Access Compliance Report

Public Rights-of-Way

(Pedestrian Signals)

Intersection ID: N/A	Main Street:	Cross Street: N/A	Location: N/A
ADA ID: 4607DF052696	Signal Type: Two Push Buttons-APS	Overall Compliance: No	Severity Score: BTN 1:N/A BTN 2: N/A No BTN: N/A
Codes/Mitigation Info/Possible Solution		Field Measurements/Component Compliance

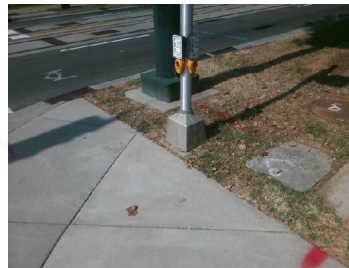
Surveyor Notes: TEXT HT 1/4

PROW/ADA: R410.6, TMUTCD 4e.08, R404.2, R406.2, , R404.7.3

Possible Solutions: Replace Signal Push Button With APS Button on New Post. Remove & Replace Sign.
